BEACON FEN
ENERGY PARK

Planning Inspectorate Reference: EN010151

Consultation Report - Appendices (Chapters 7-10)

Appendix 7 - Statutory Consultation under Section 42

I am writing on behalf of Asgarby and Howell Parish Council, in response to your recent letter regarding the targeted extensions for certain consultees.

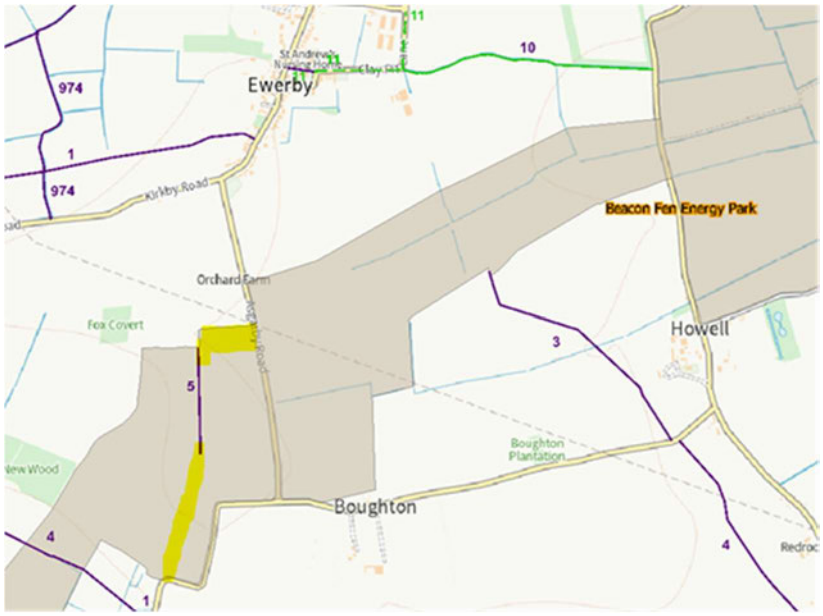
Yours faithfully,

Acting clerk to the Asgarby and Howell Parish Council.

Appendix 10.7 Second targeted consultation consultee responses

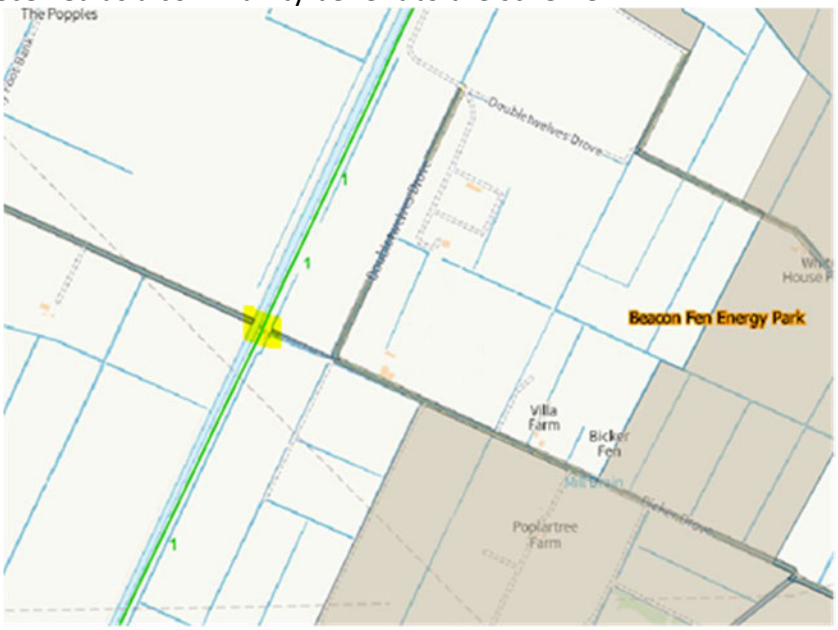
[via email:[redacted]@lowcarbon.com]

SHEET 1 OF 8

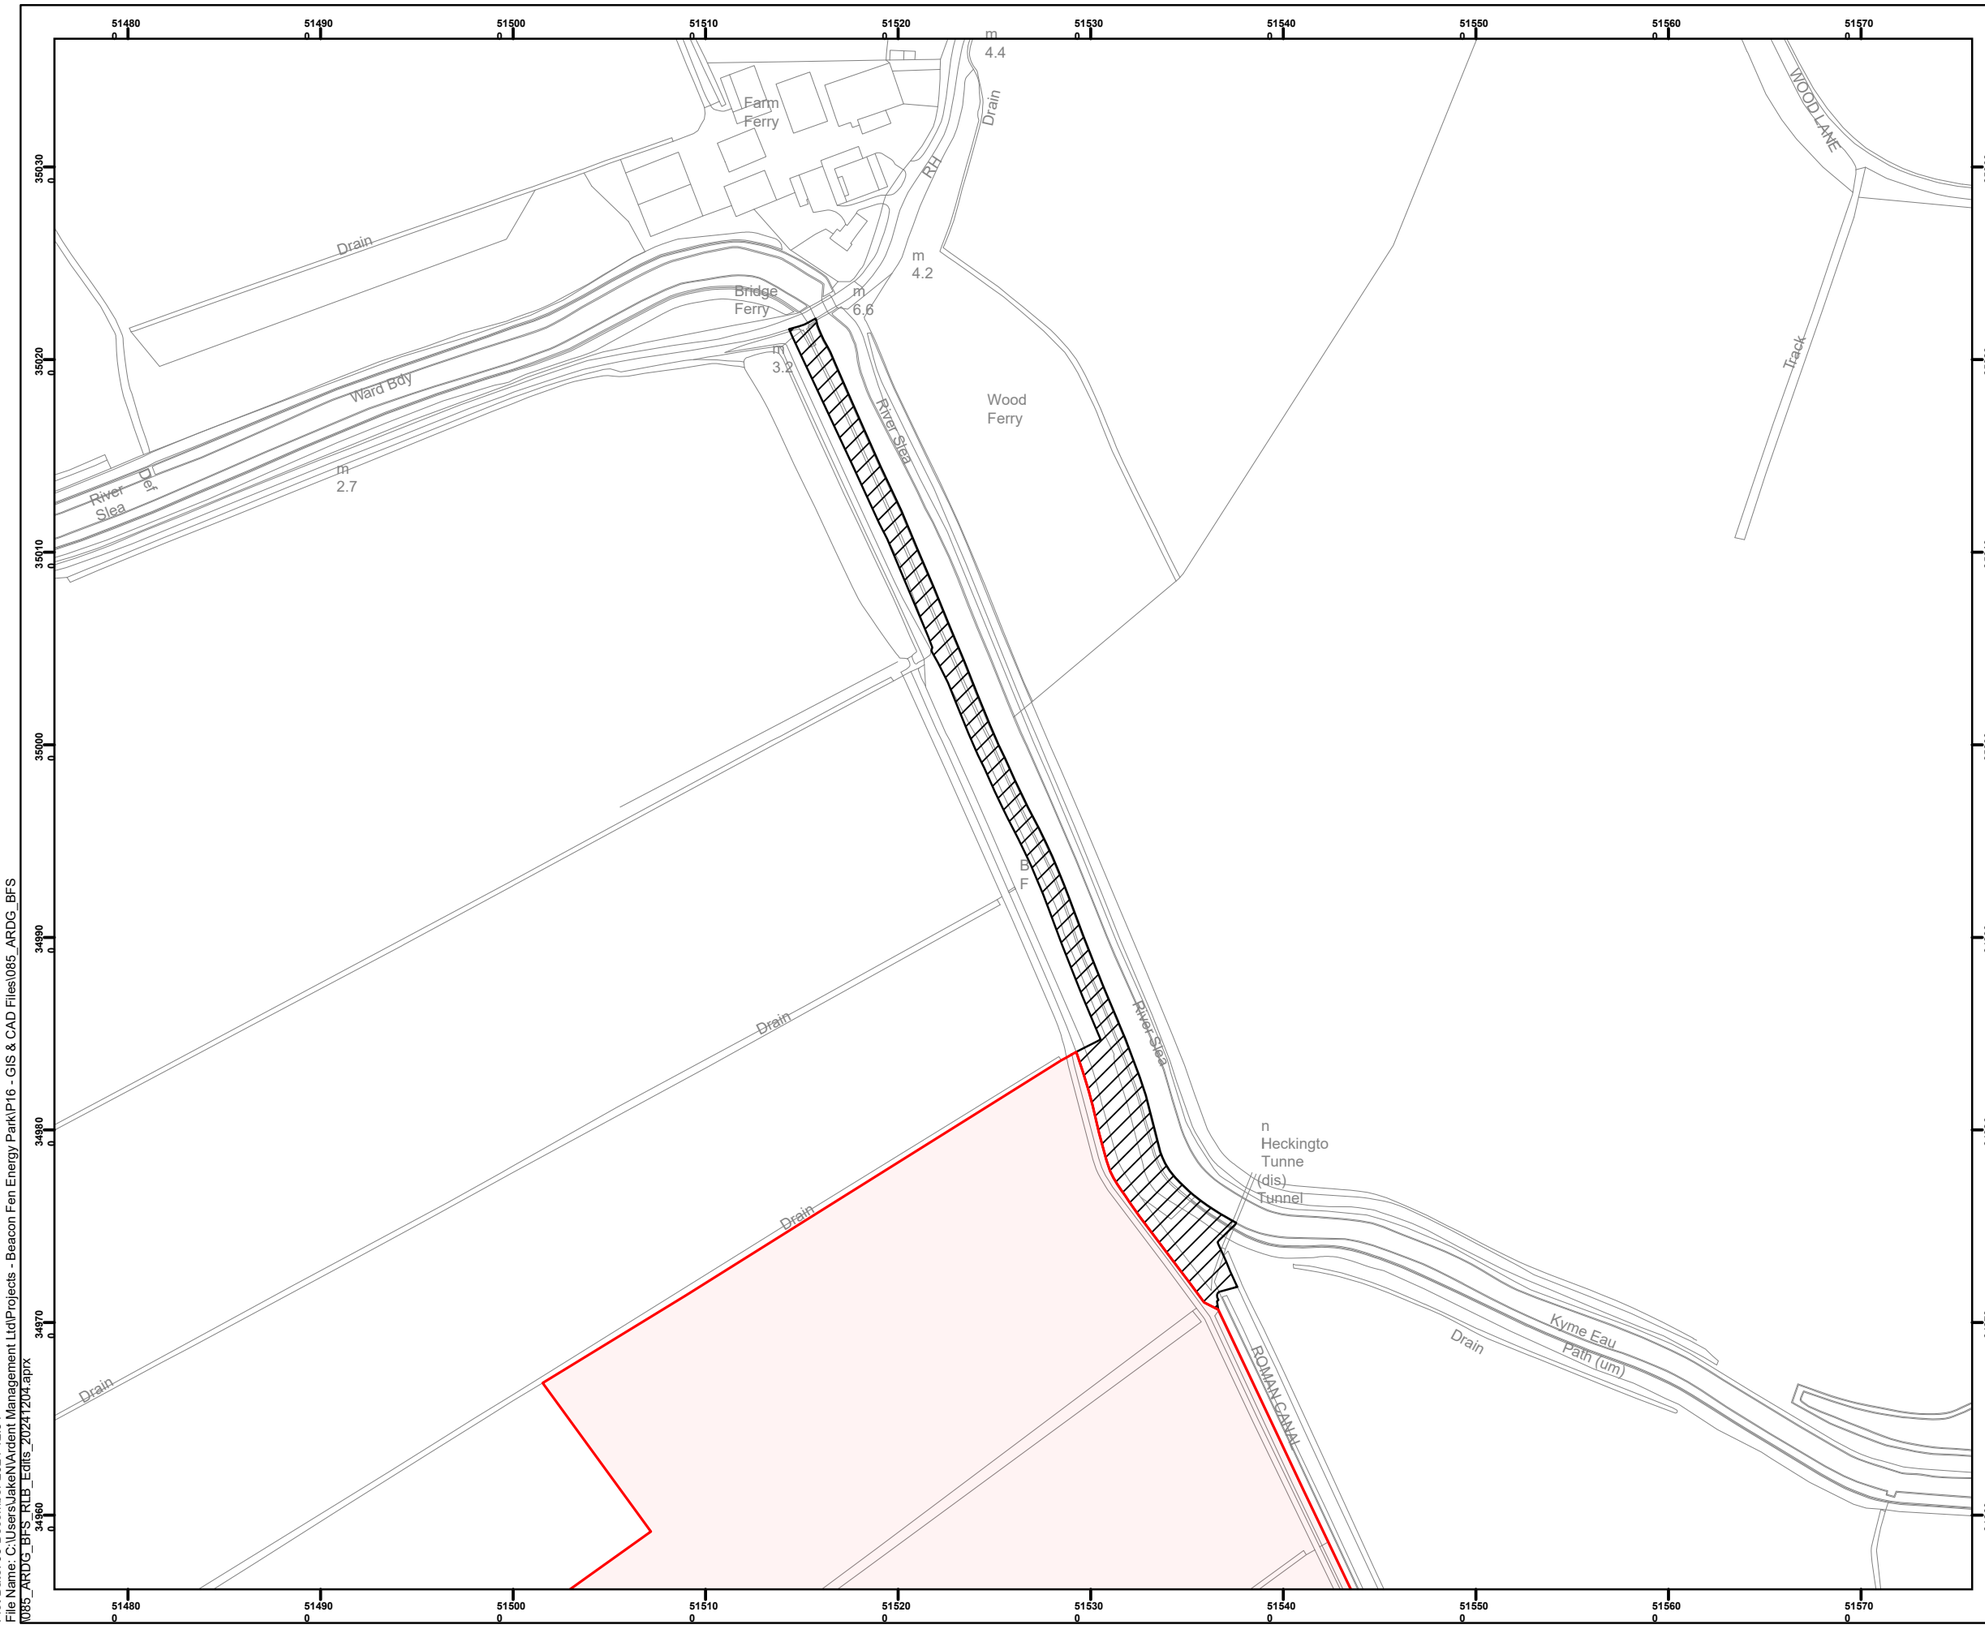
In terms of the targeted consultation, as the additional land on sheet 1 lies close to the River Slee, it would be prudent to consult with the Environment Agency as well as the IDB.

Sheet 1
The increases in the order limits now mean that the river Kyme Eau's embankments are included. Care will need to be taken to ensure that any works and/or use for haul roads does not compromise the stability of the embankments. Additionally, you should undertake an assessment of the embankments to understand their condition and level of protection. Furthermore, the extended order limits now also include a gauge board. You will need to clarify whether your project will alter flow levels or flow rates, so this can be taken in to consideration when using the gauge boards.

SHEET 4 OF 8

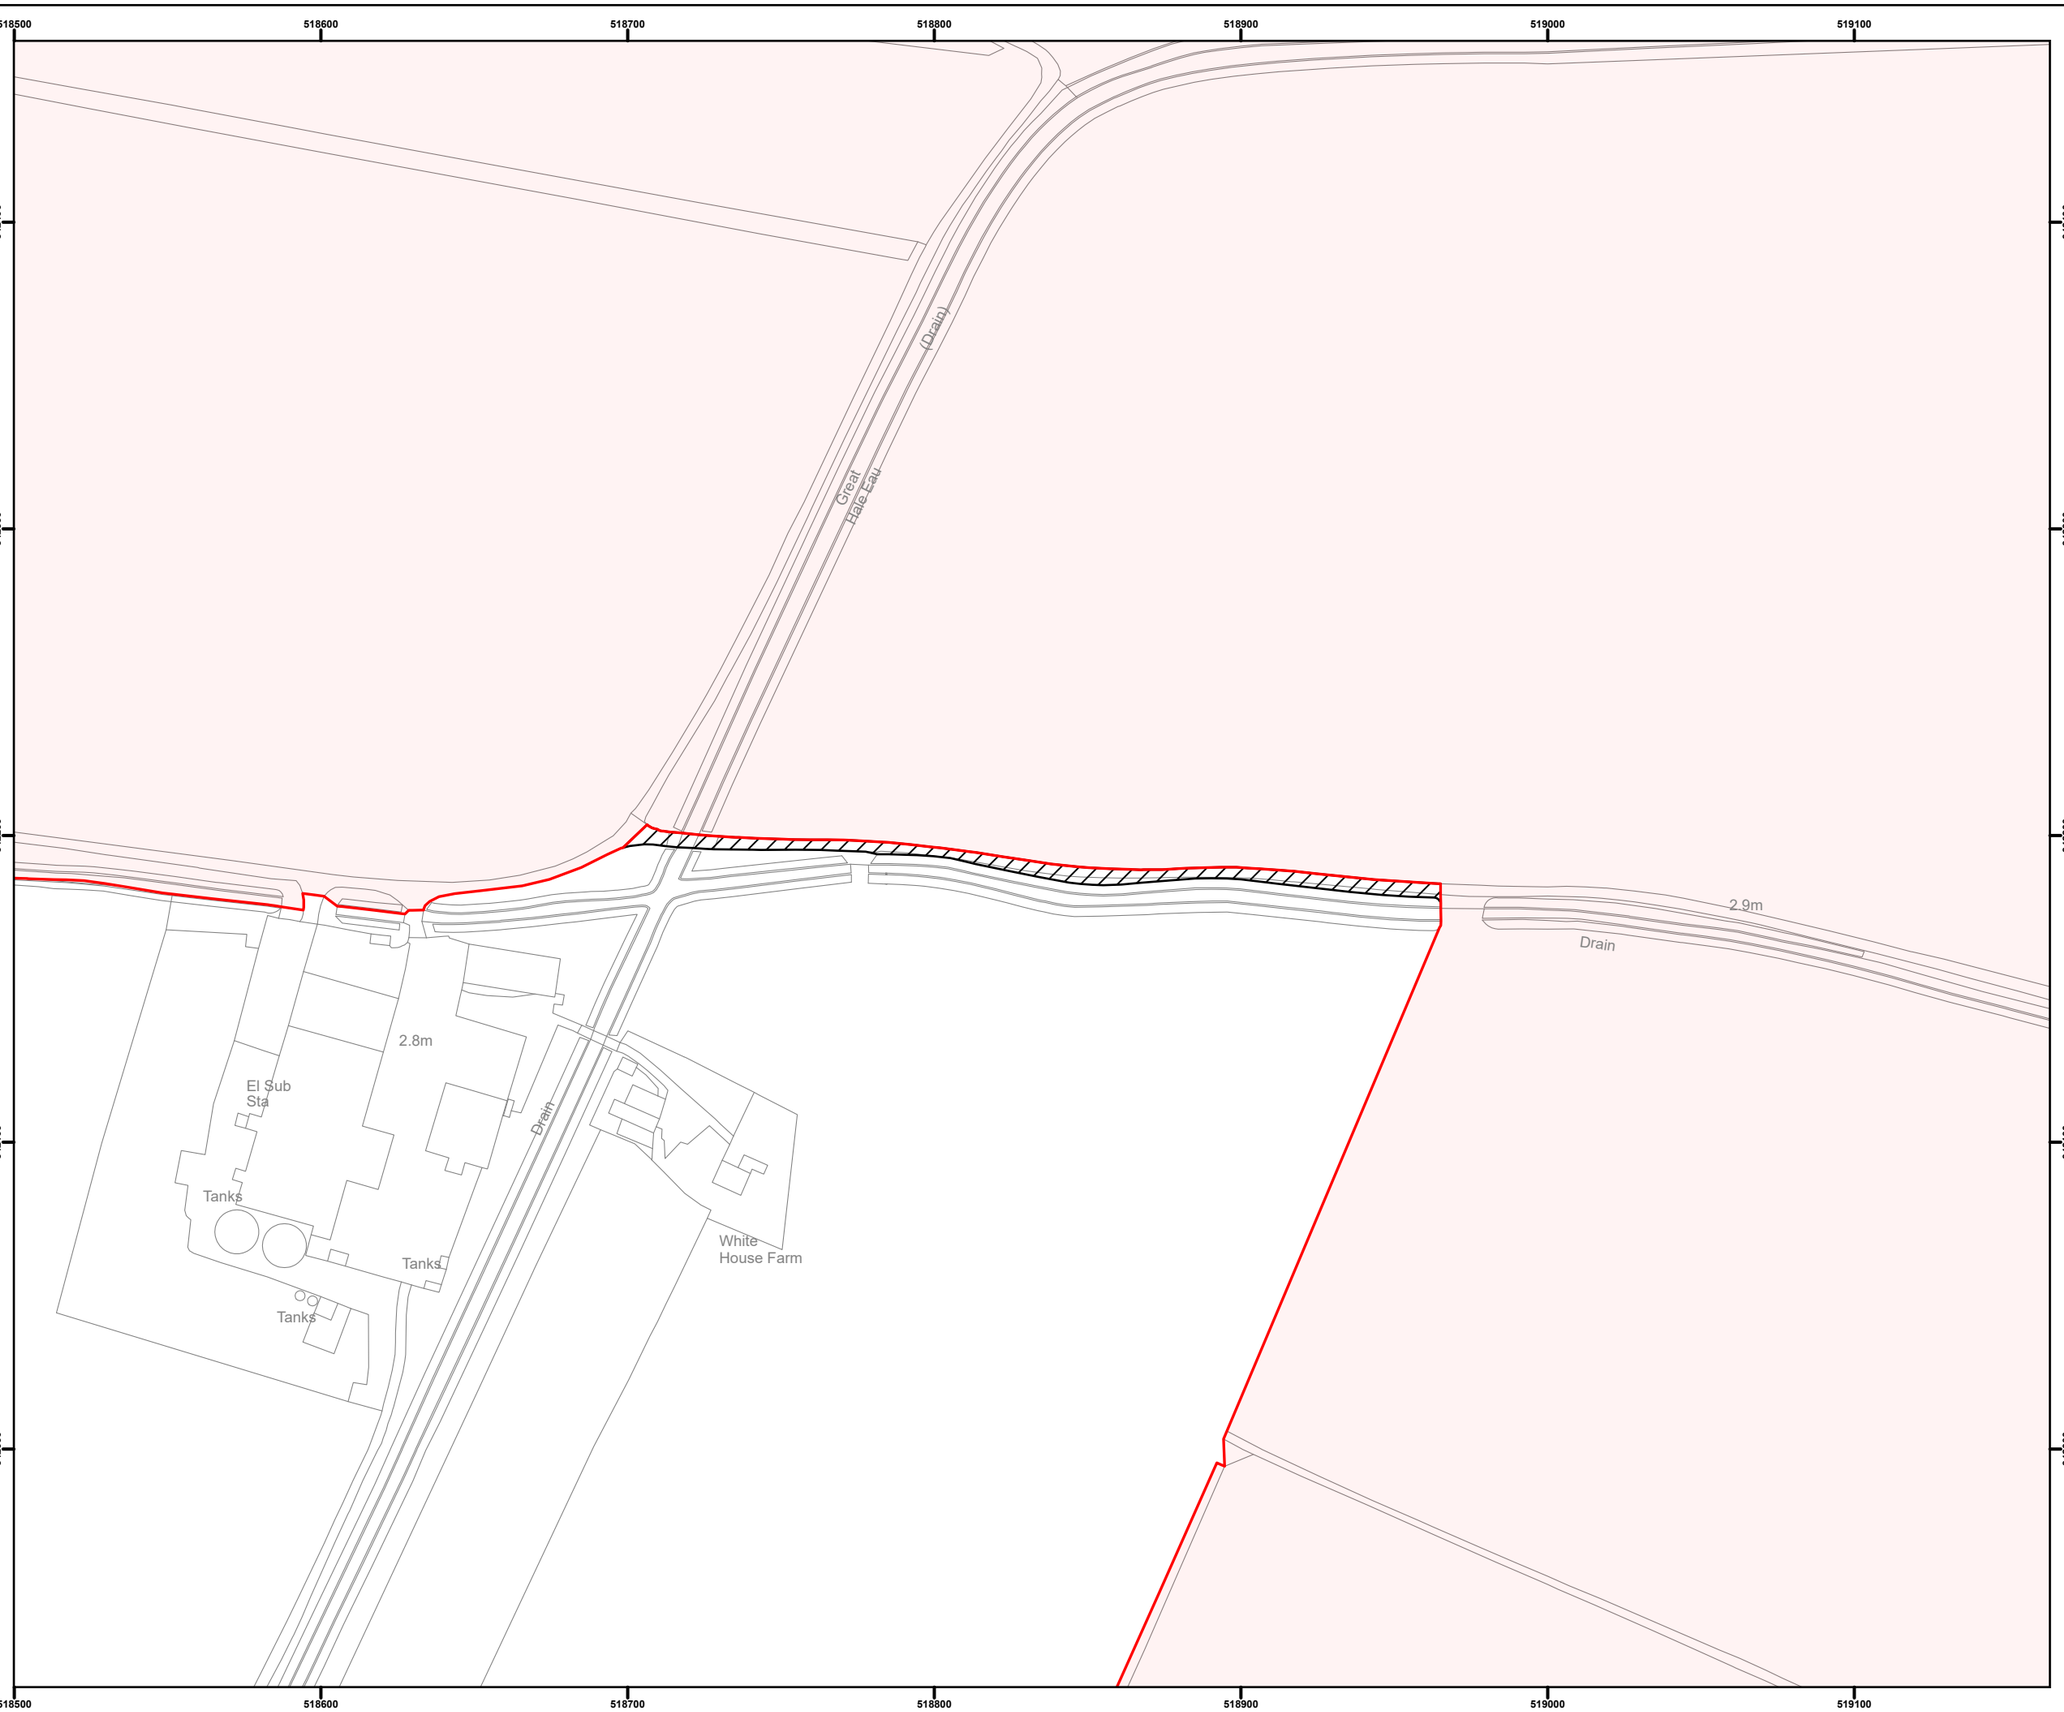
The only map pertinent to Howell is the shaded area on sheet 4 of 8. It shows the verge and access to the concrete loading area on the Howell fen road. It is a hard stoned area linking the highway to the concrete slab and roadway. The area is maintained by the farmer and has no relevance to the Parish council.
